ARCHITECTURAL ACOUSTICS

DAYTON PRIMARY SCHOOL - DD REPORT

23rd April 2021

PROJECT: Dayton PS - Acoustics DD Report **PROJ No:** 21-004

GA FLOOR PLANS LEVEL GROUND

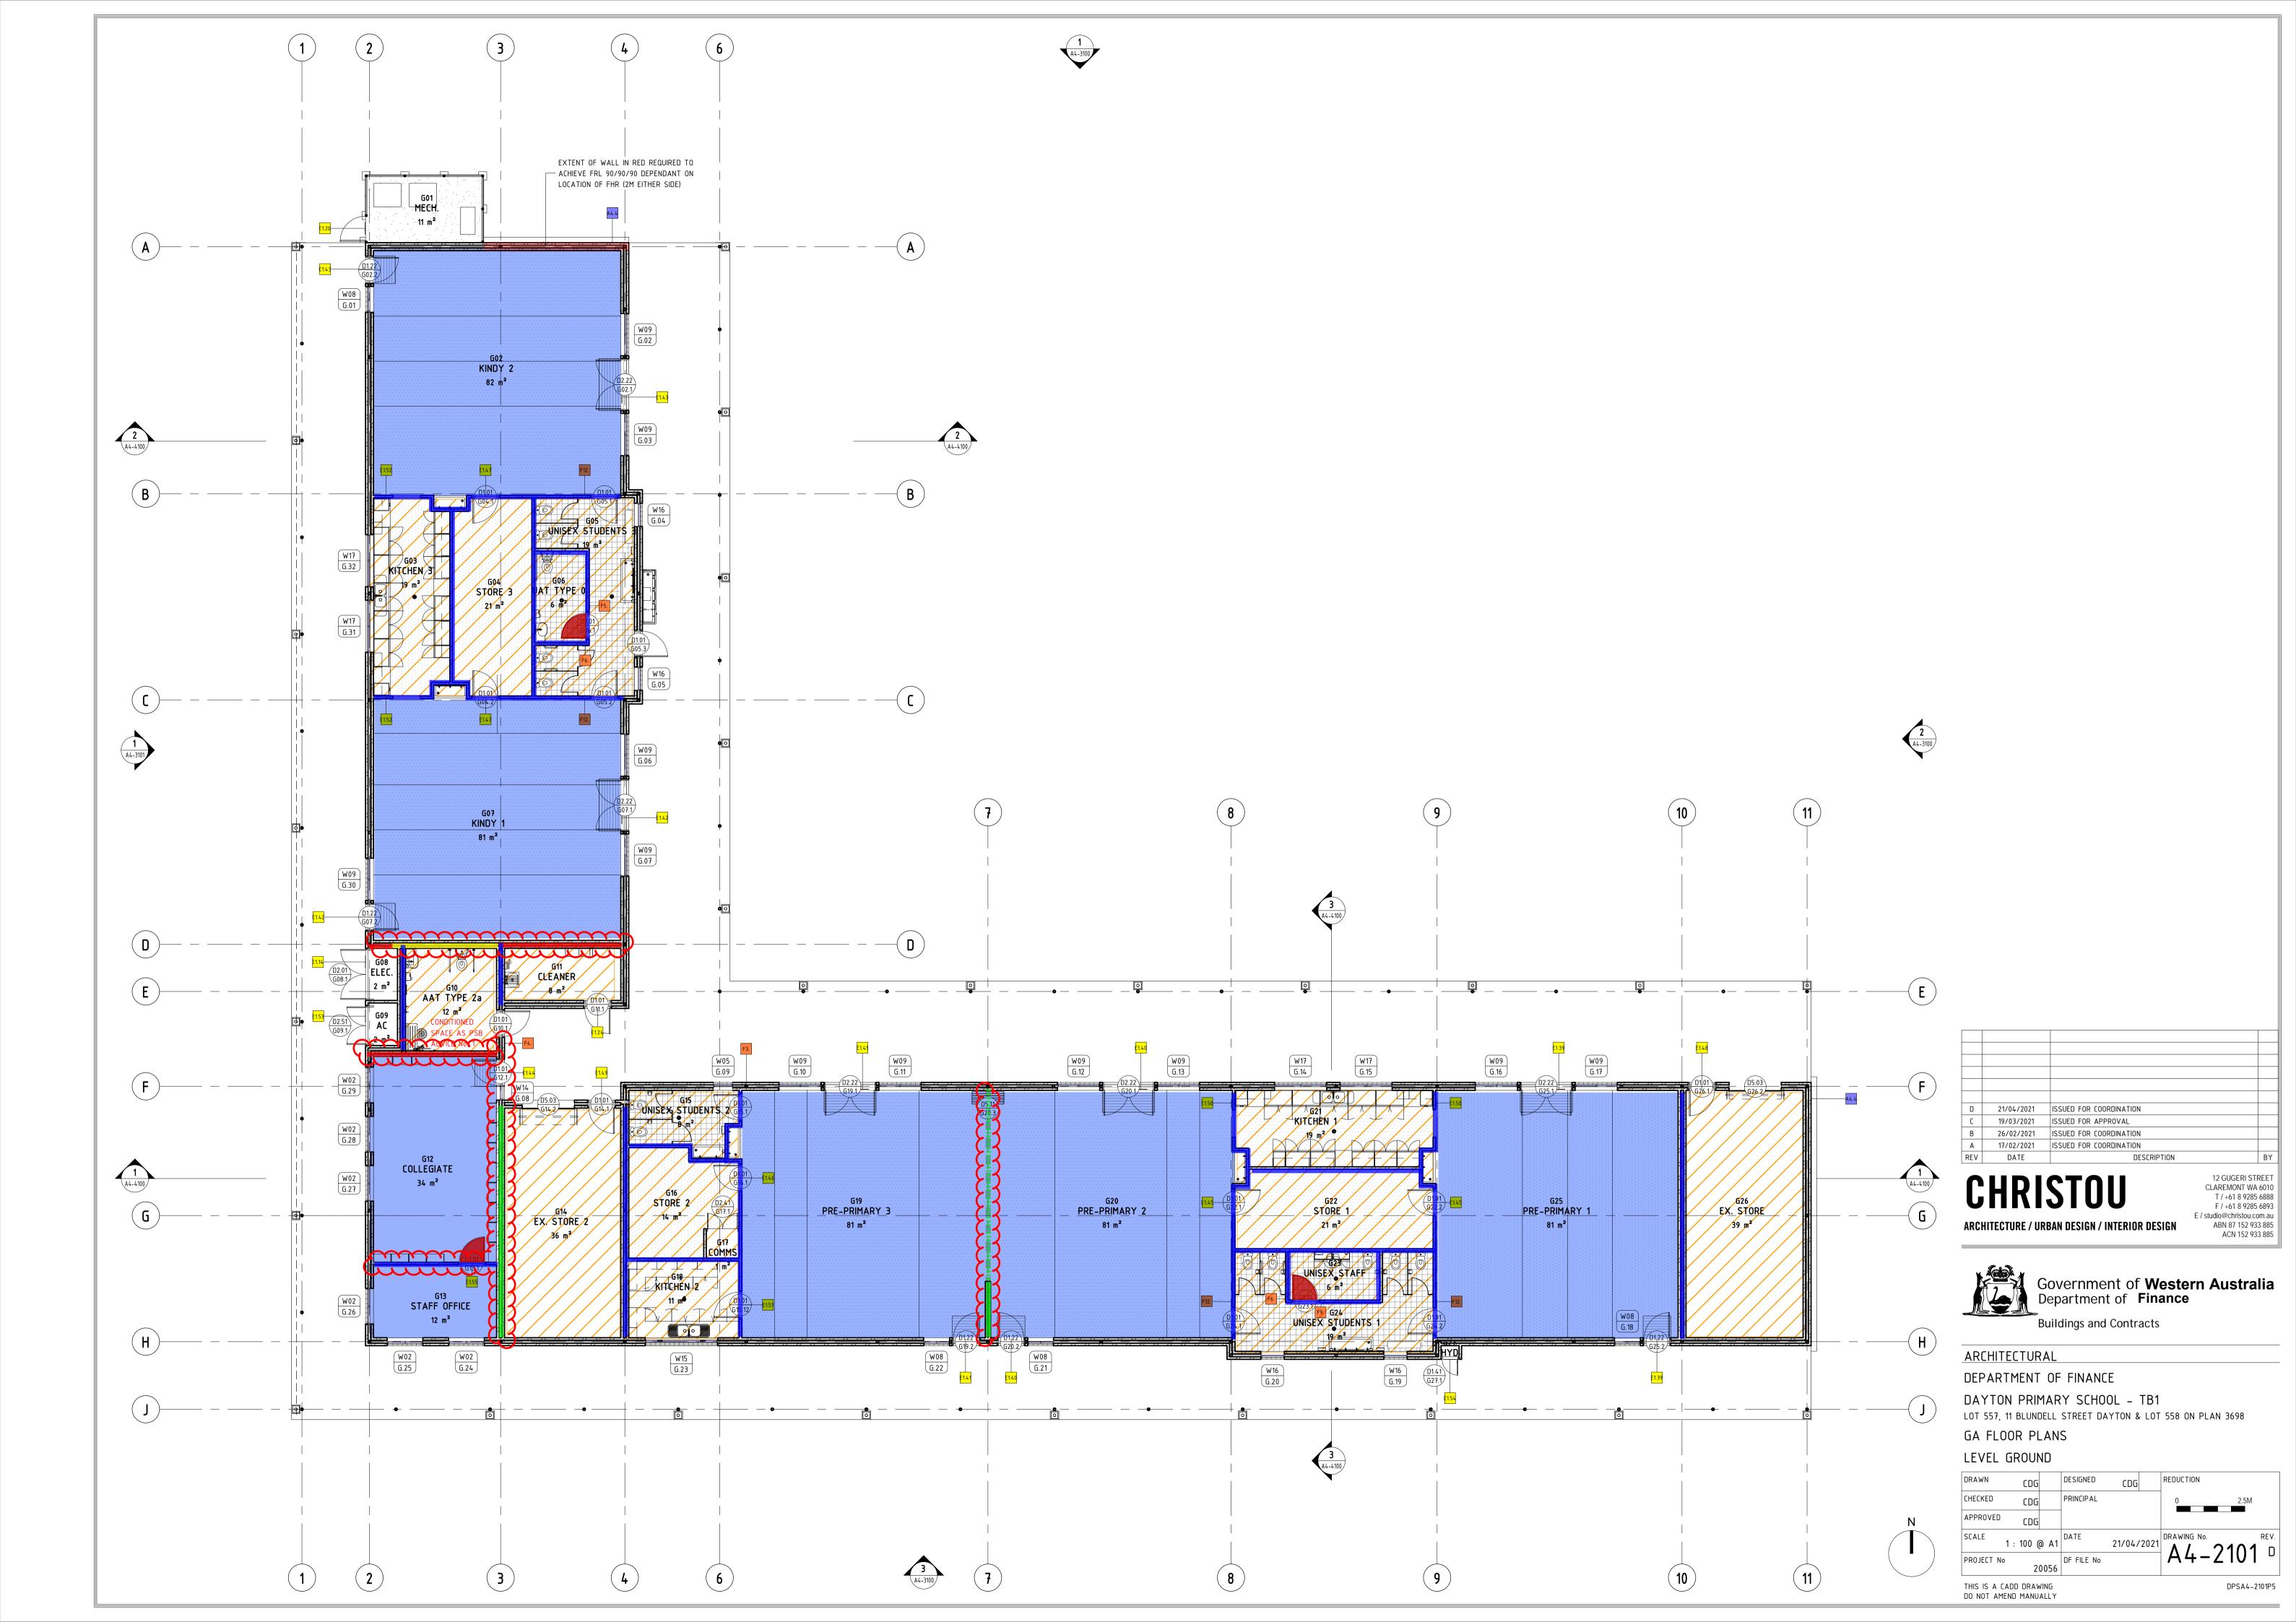
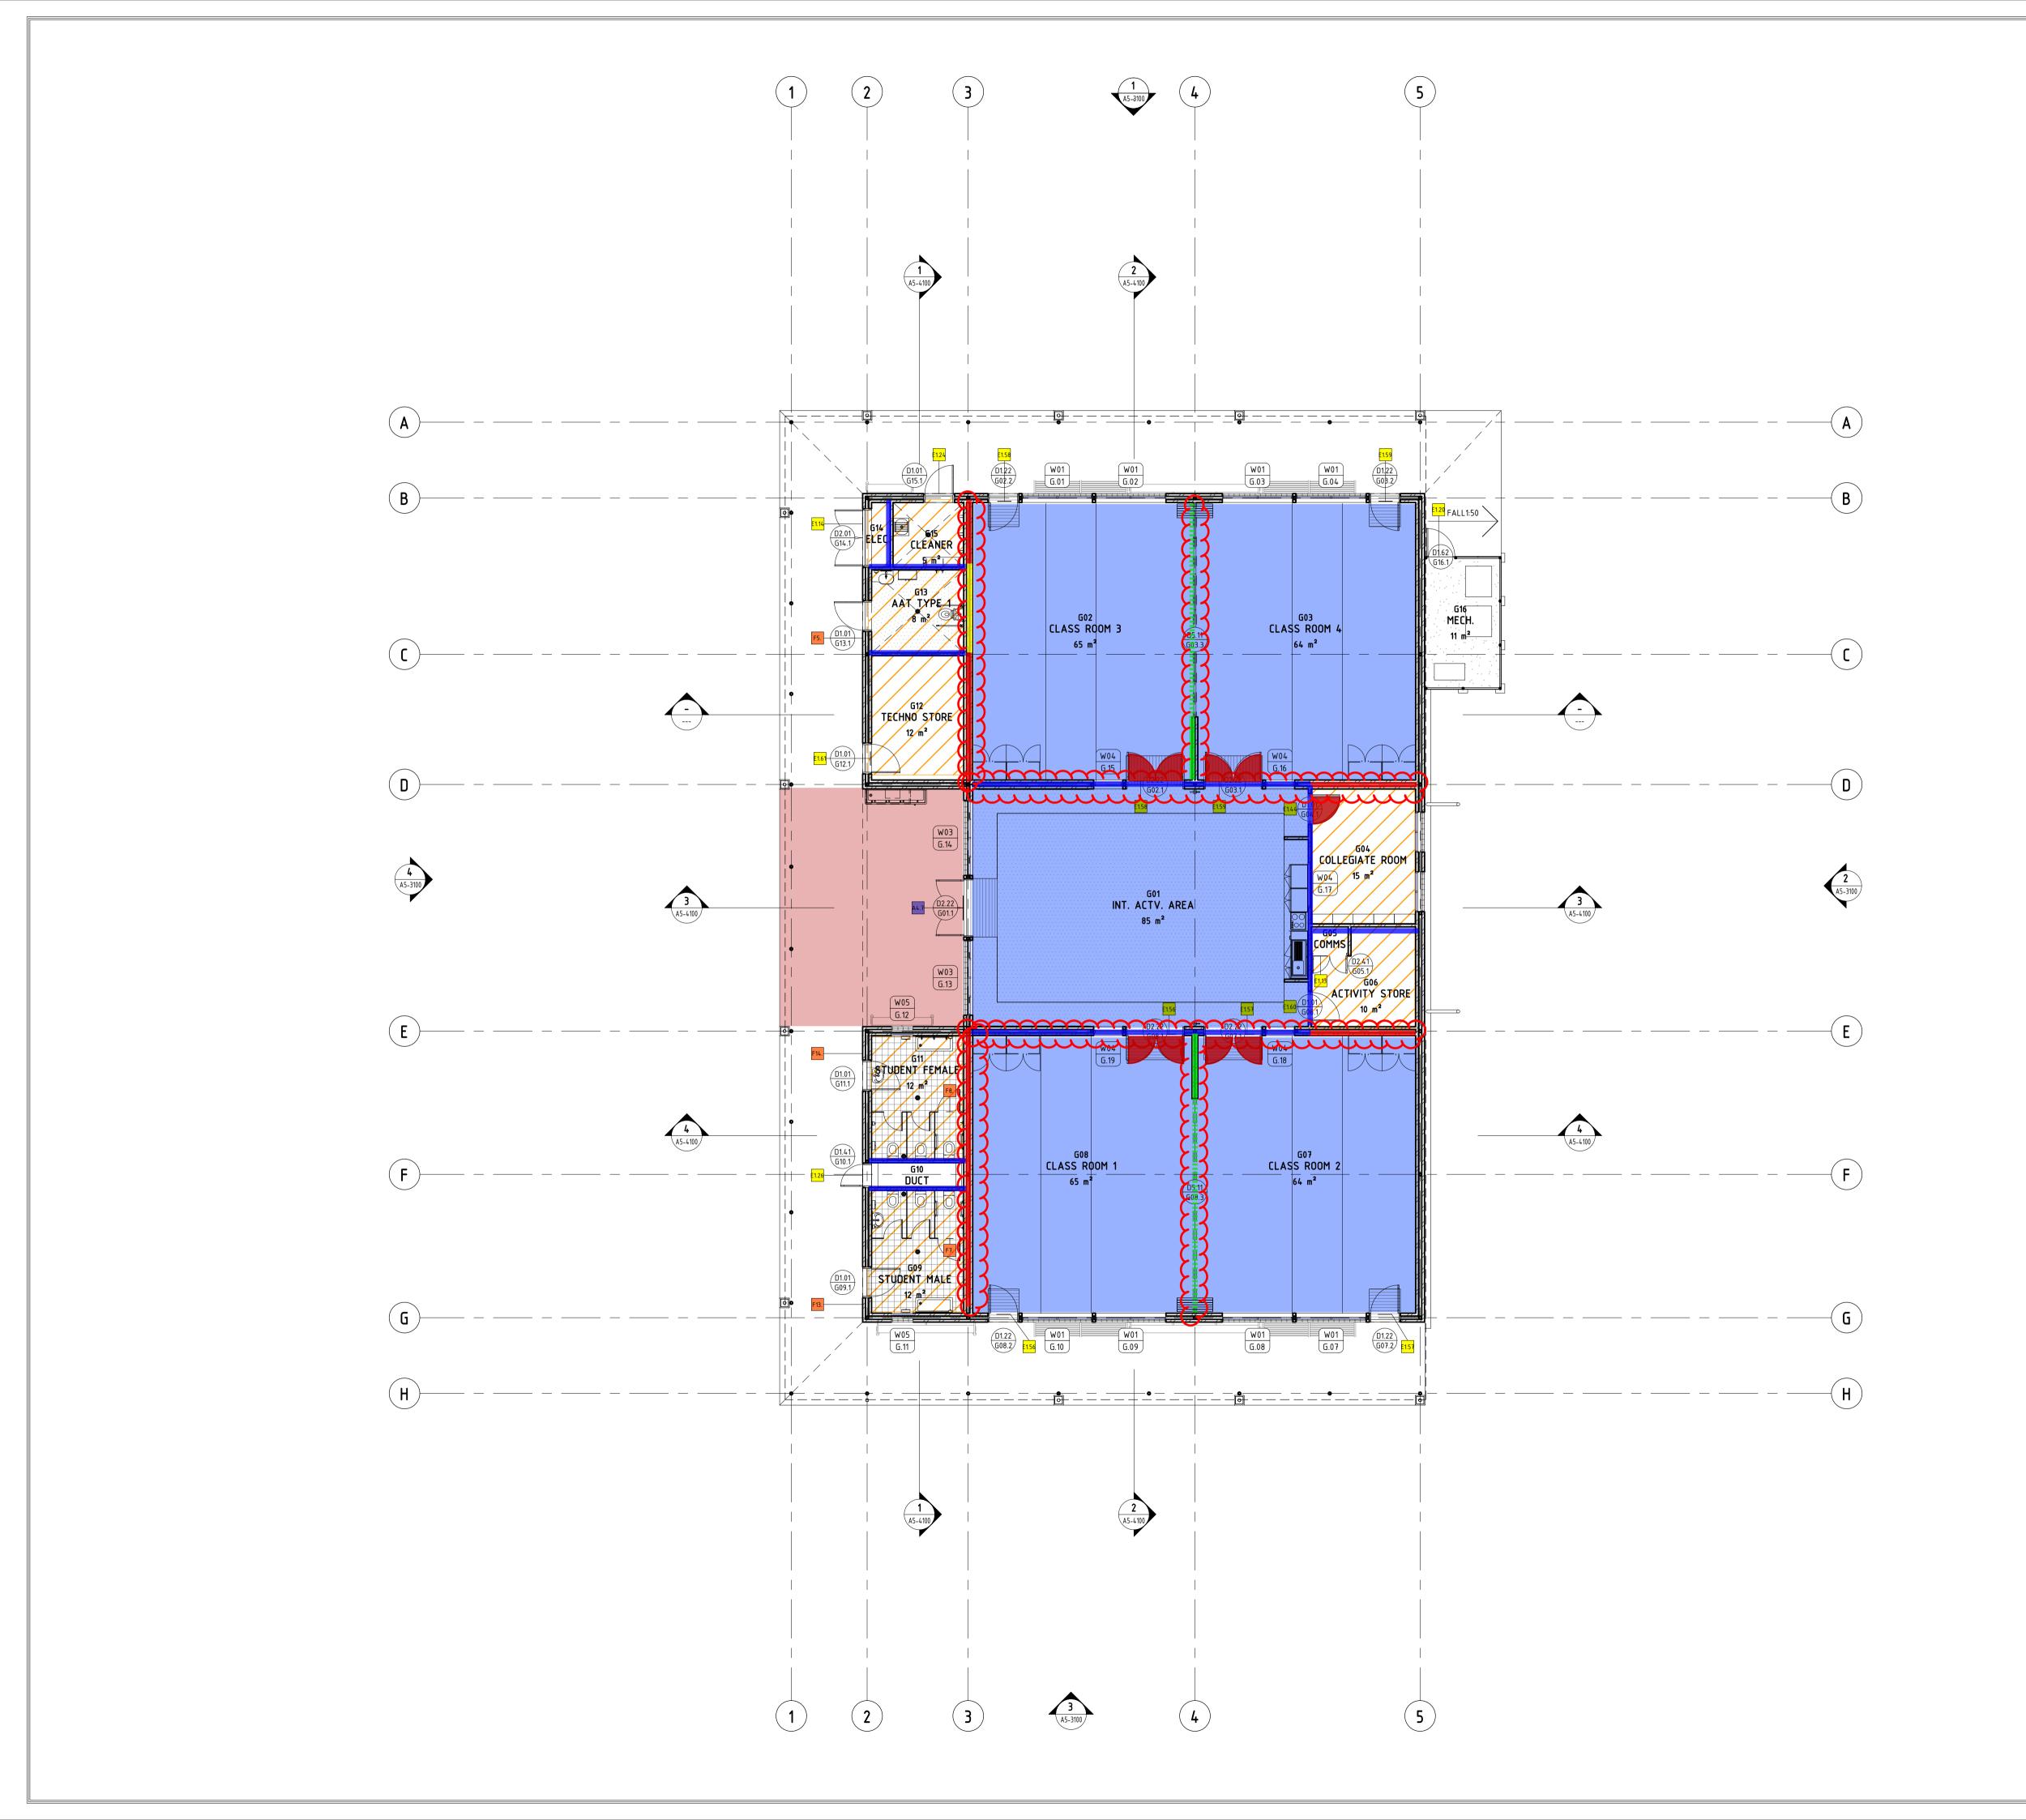
The operable wall between Music and Covered Assembly should be R_w 52, as both spaces may accommodate noise generating activities. Even this is not considered soundproof, but represents a practical level of noise control for this planning arrangement.

Do **NOT** provide a flush plasterboard ceiling in the Covered Assembly area. This will result in an unacceptably high reverberation level. If a ceiling is to be incorporated, now that this is basically a fully enclosed space, the system must be selected on the basis of maximum practical acoustic absorption (no less than NRC 0.75).
